City of Dublin

Memo

Re: Resolution 02-21 – Acceptance of a Preliminary Plat to subdivide ±3.58 acres into two lots and to dedicate right-of-way for one Neighborhood Street for the future development of the Primrose School (Case #20-148PP)

20-148PP
Preliminary Plat
Primrose School
PID: 273-009147

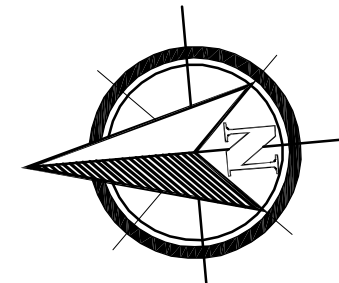
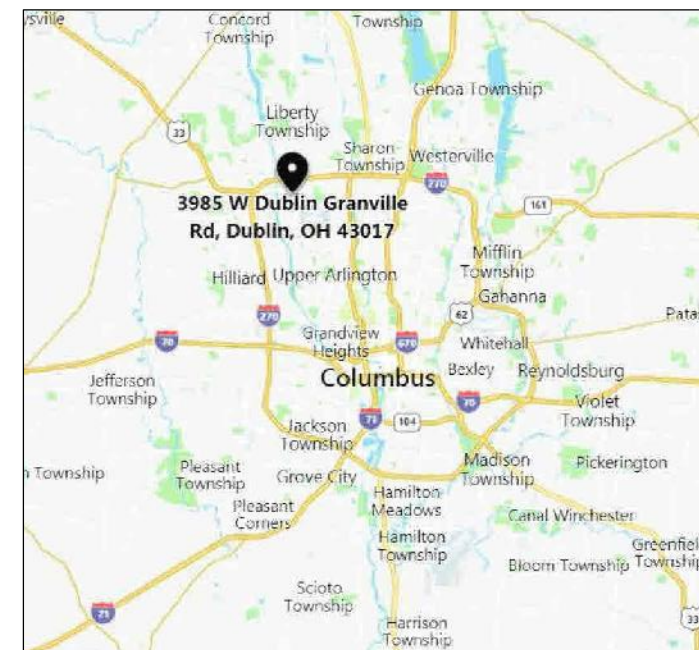
- 1) The applicant make any minor technical adjustments to the plat prior to submission for acceptance to City Council, and;
- 2) The applicant shall provide a street name for the proposed neighborhood street prior to the submission to City Council for approval.

The Planning and Zoning Commission reviewed and recommended to City Council the plat acceptance. Condition 2 has not been met and the applicant will continue to work with Engineering to finalize a street name for the proposed neighborhood street prior to the submission of the Final Plat application.

- 1) The applicant shall provide a street name for the proposed neighborhood street prior to the submission of a Final Plat application.
